Marin Headlands and Fort Baker Transportation Infrastructure and Management Plan

Final Environmental Impact Statement

March 2009

FIGURE 4.2 PEAK-SEASON WEEKEND TRAFFIC VOLUMES — YEAR 2023

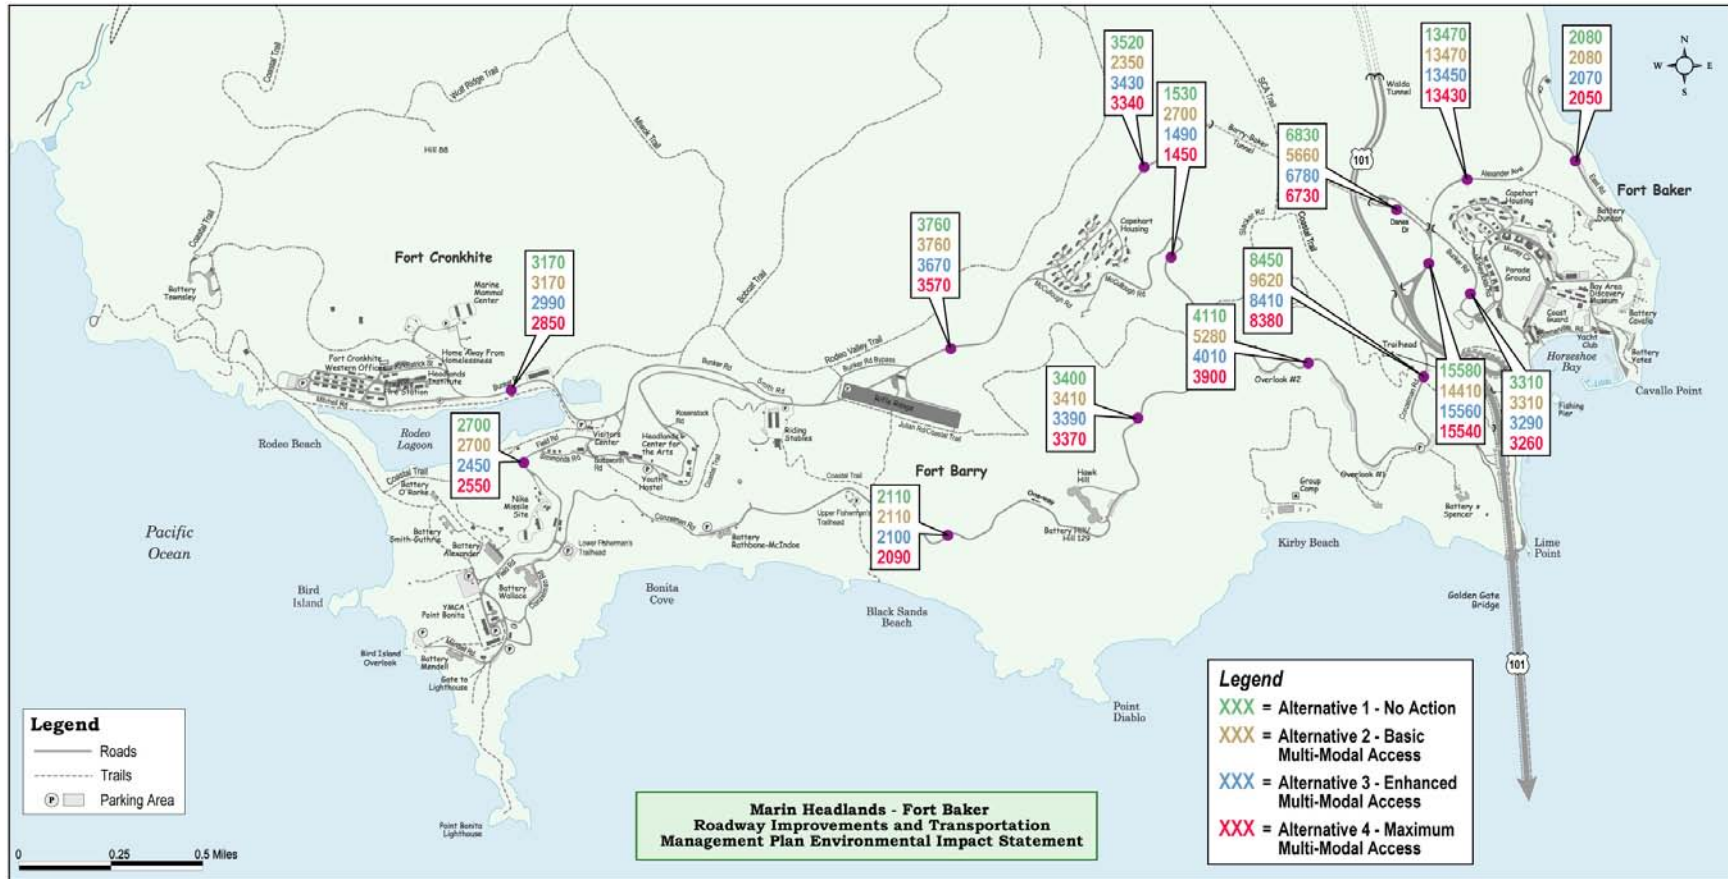
| <p>9. Section 4.2.2, Traffic, Figure 4.2 provides estimated 2023 traffic levels. LOS analysis of Alexander Avenue at Highway 101 and Danes Drive for the four alternatives is referenced without supporting data. Results for Alternatives 1 and 3 are summarized as "no change" and "negligible", while Alternative 2 notes that Alexander/Danes "could be signalized" to avoid minor adverse impacts on LOS, and Alternative 4 notes the possibility of a signal despite negligible LOS impact. District requests that detailed traffic analysis data be presented in the EIS to support findings.</p> | J-11 |

Section 4.2.2, Traffic, Figure 4.2 provides estimated 2023 traffic levels. LOS analysis of Alexander Avenue at Highway 101 and Danes Drive for the four alternatives is referenced without supporting data.
